ARC REVIEW CODE: R2105262

TO: Mayor William Edwards  
ATTN TO: Marissa Jackson, Planner  
FROM: Douglas R. Hooker, Executive Director  
RE: Development of Regional Impact (DRI) Review

**Name of Proposal:** Sandtown Village DRI #3290

<b>SANDTOWN VILLAGE DRI #3290</b> <b>HUTCH DEVELOPMENT</b> FULTON COUNTY, GEORGIA
CAMP CREEK PKWY AT CAMBELL TON RD
<b>REZONING SITE PLAN</b>

# C1.1

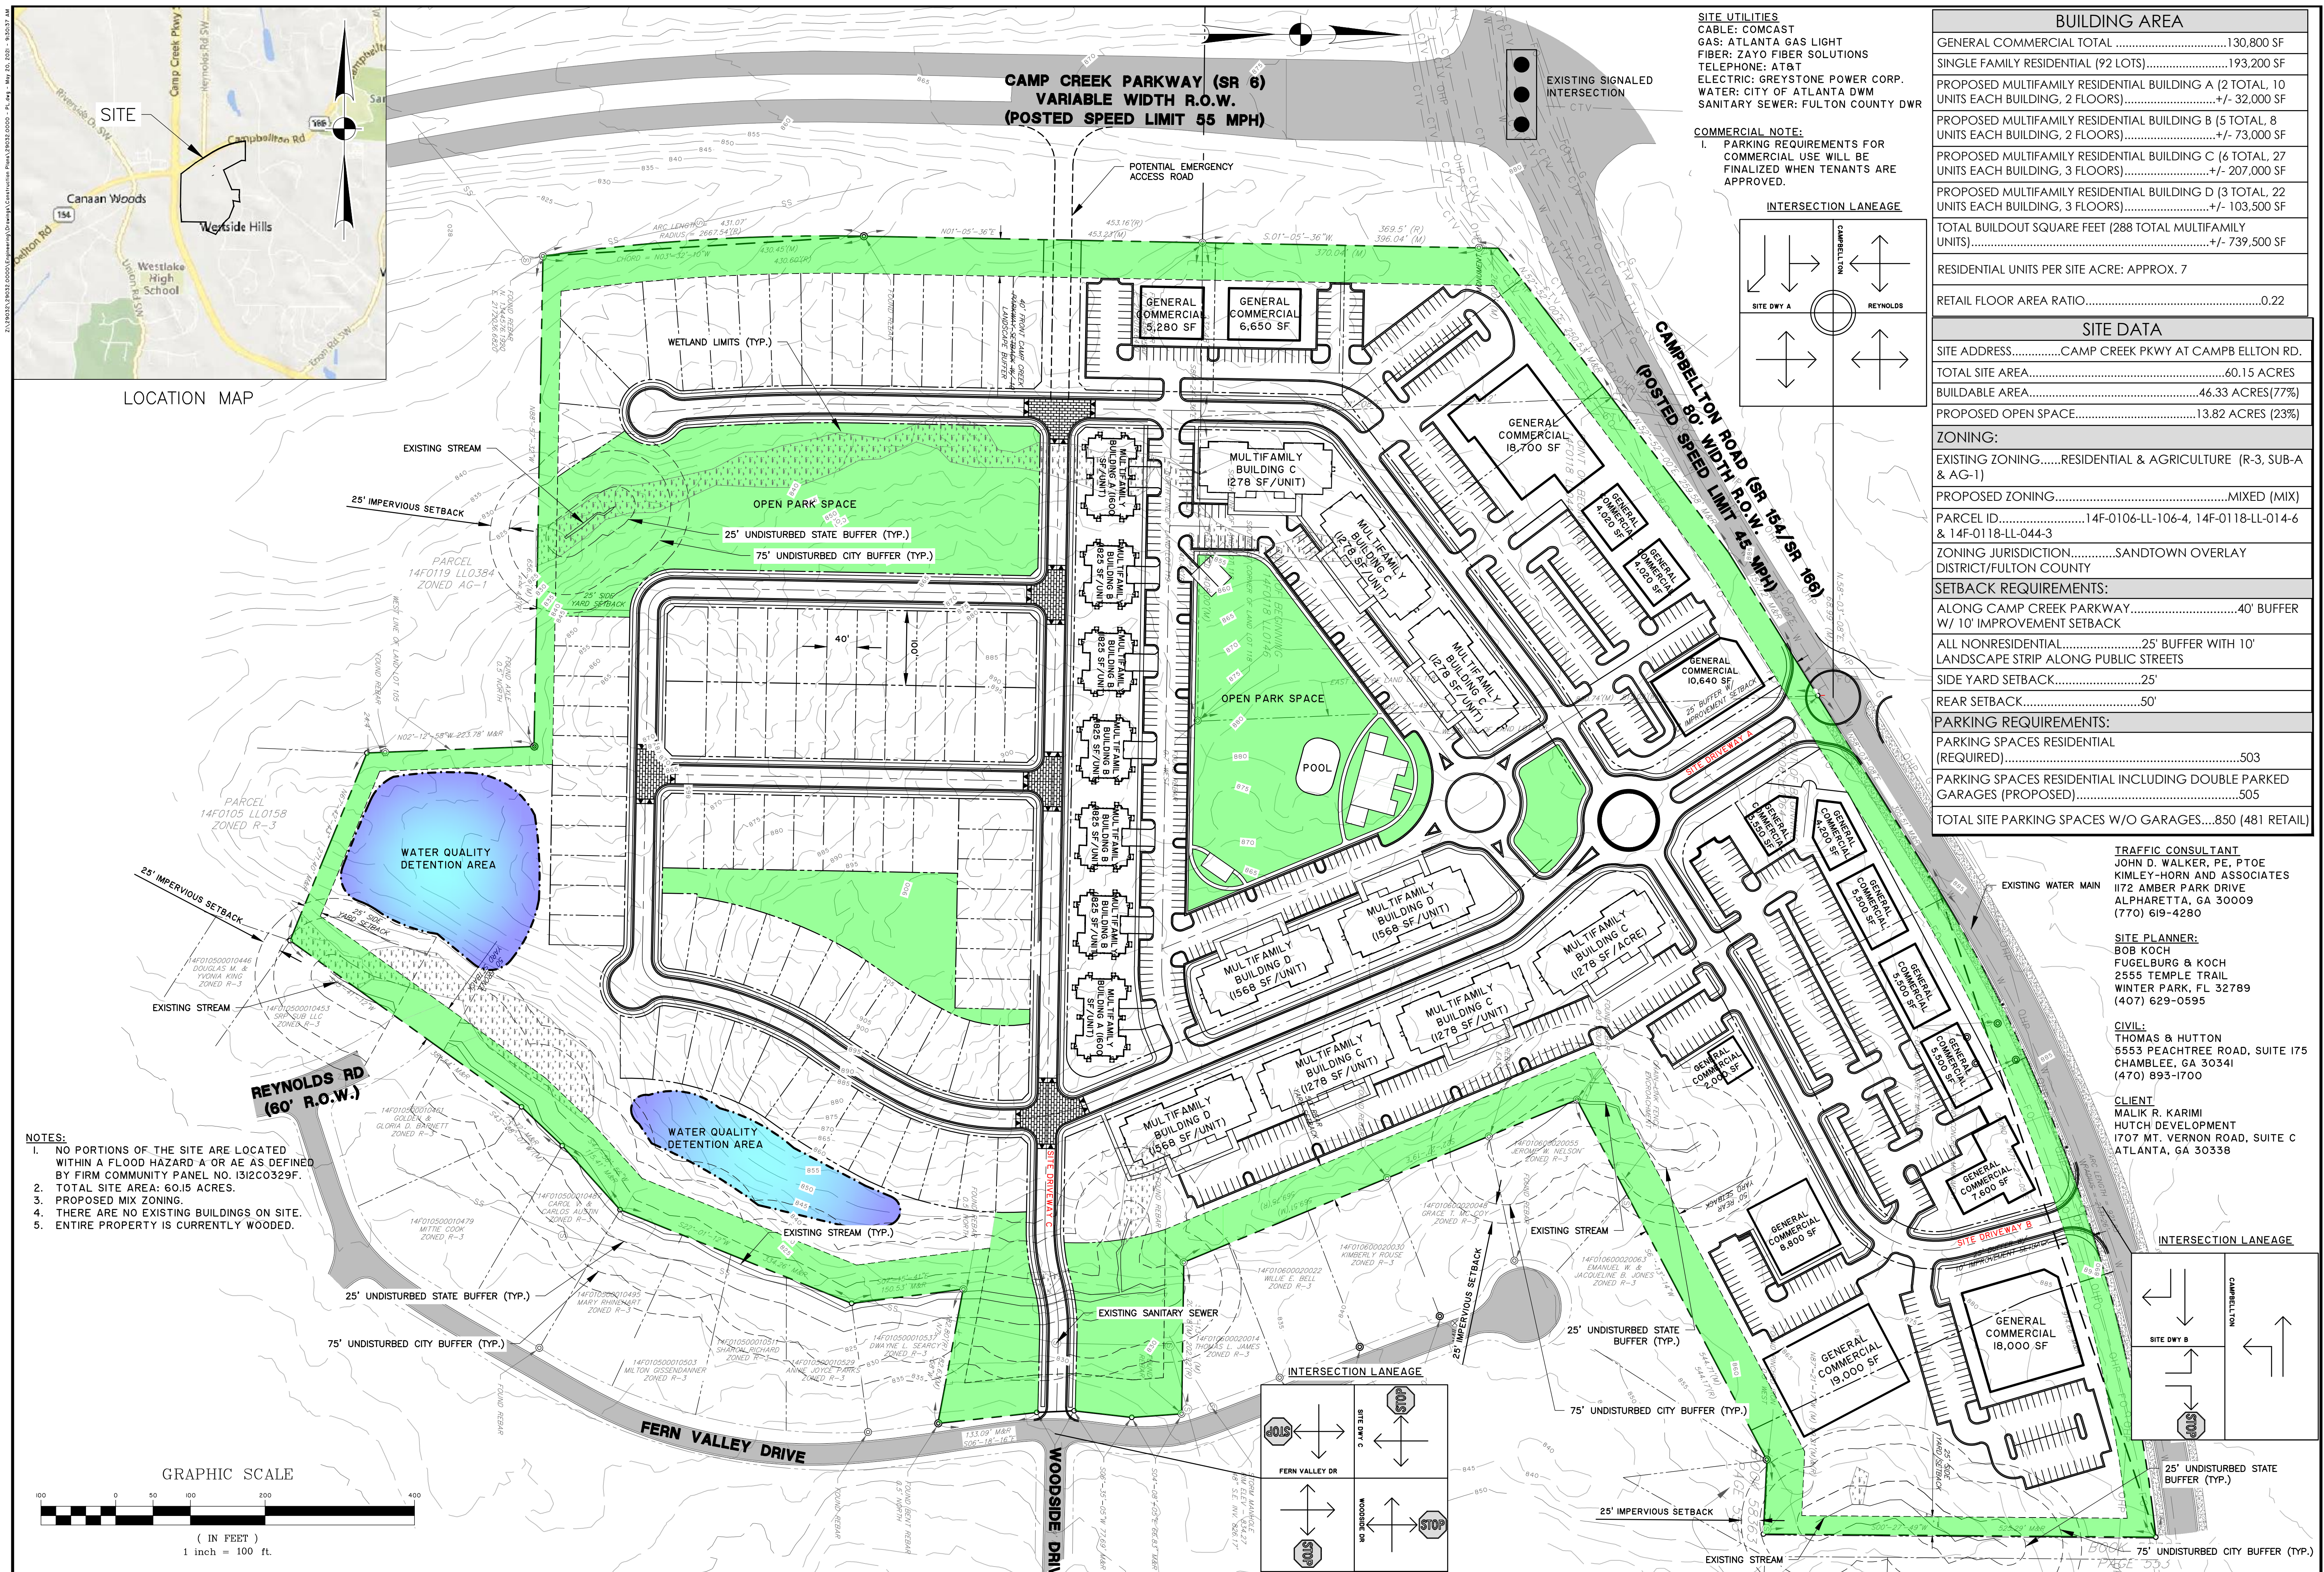
alternative mode. As presented, the site plan appears to show sidewalks on the internal streets, but no crosswalks at various locations are indicated. Both the central park space and the majority of the commercial uses are surrounded by surface parking without clear pedestrian pathways. Please see the attached comment from GDOT's aviation division regarding construction equipment heights.

The project can further support The Atlanta Region's Plan in general by incorporating other aspects of regional policy, including green infrastructure and/or low-impact design (e.g., rain gardens, vegetated swales, etc.) in parking areas and site driveways, and as part of any improvements to site frontages. Please see the attached comments from ARC's Natural Resources Group, which note that this project is in the Camp Creek watershed and could become part of the Chattahoochee River large water supply watershed when proposed intakes for South Fulton and Coweta County are built downriver. They also note that there appear to be some intrusions from the multifamily parking onto the City's stream buffer and impervious setback that may require variances.

The USGS coverage for the project area shows an unnamed tributary to Camp Creek near the southeastern boundary of the project property. The submitted site plan shows this stream, as well as two other stream segments on the south side of the property and one on the west side of the property. All show a 75-foot undisturbed buffer and additional 25-foot impervious surface setback that is consistent with the city of South Fulton's Stream Buffer Ordinance. The State 25-foot Erosion and Sedimentation Act buffers area also shown. However, some intrusions into the City undisturbed buffer and impervious setback are shown, including some of the parking areas for the multi-family portion of the project. These intrusions may require a variance from the City. A stream crossing may require a variance from the State 25-foot Erosion and Sedimentation Act buffer. Any unmapped streams on the property may also be subject to the City Stream Buffer Ordinance. Any unmapped waters of the State on the property may be subject to the 25-foot state Erosion and Sedimentation Act buffers.

Based on the review of the site plan, a potential emergency access is referenced at Camp Creek Parkway/SR 6 and the adjacent side of the development.

There are no proposed bicycle improvements.
